survey for
Karon Morris

PETITION No.: V-37

TYPE OF VARIANCE: Waive the rear setback from the required 40 feet to 37 feet.

Application for Variance

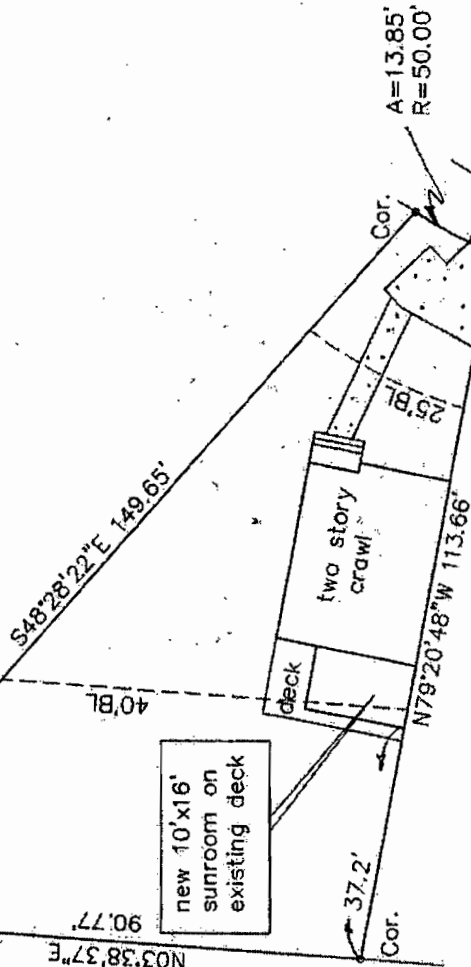
SITE PLAN REVIEW: If this variance request is approved, a subdivision plat revision must be recorded prior to the issuance of the certificate of occupancy showing all improvements on the lot along with any approved setback reductions, and referencing the variance case in the standard plat revision note. The surveyor must submit the plat to the Site Plan Review Section, Community Development Agency for review and approval prior to recording. Call 770-528-2147.

STORMWATER MANAGEMENT: Any roof downspouts must be discharged to the ground at the structure to maximize overland flow of runoff.
